ANALYSIS OF NORTH LOOP DESIGN CHANGES AND DETERMINATION RE:

NO SUPPLEMENTAL ANALYSIS IS NEEDED ON EA AND FONSI

The Department of Energy (DOE) evaluated the Environmental Assessment for the Rebuild of the North Loop 230-kV Electrical Transmission Line, Hanford Site, Washington (DOE/EA-2033, Final EA) in light of Bonneville Power Administration's (BPA) final design changes. Those changes could have bearing on the potential environmental impacts. This memo identifies the standards and describes the information analyzed to determine whether (1) to supplement an existing EA, (2) to prepare a new EA or EIS, or (3) no further NEPA documentation is required.¹

FIGURE 3 – STEEL LATTICE TOWER AND STEEL MONOPOLE DESIGN

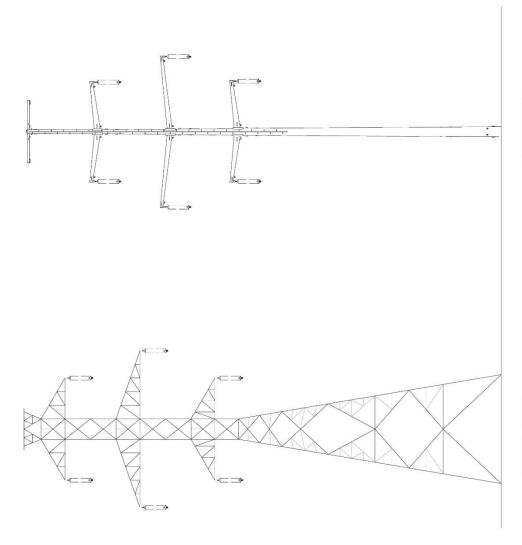
- Some sections of the electrical transmission system would substitute steel lattice towers where tubular steel monopoles were planned (Figure 3) and reuse existing single circuit poles and steel lattice towers, where appropriate.

Changes involve use of single circuit steel lattice towers instead of steel monopoles with the original design otherwise remaining the same. Temporary conductor pulling and tensioning stations would also be required. The APE was expanded but did not result in new adverse effects to cultural resources that were not addressed in the original determination of adverse effects and their resolution through the MOA. The ecological study area also expanded but effects are temporary and affected areas would be revegetated.
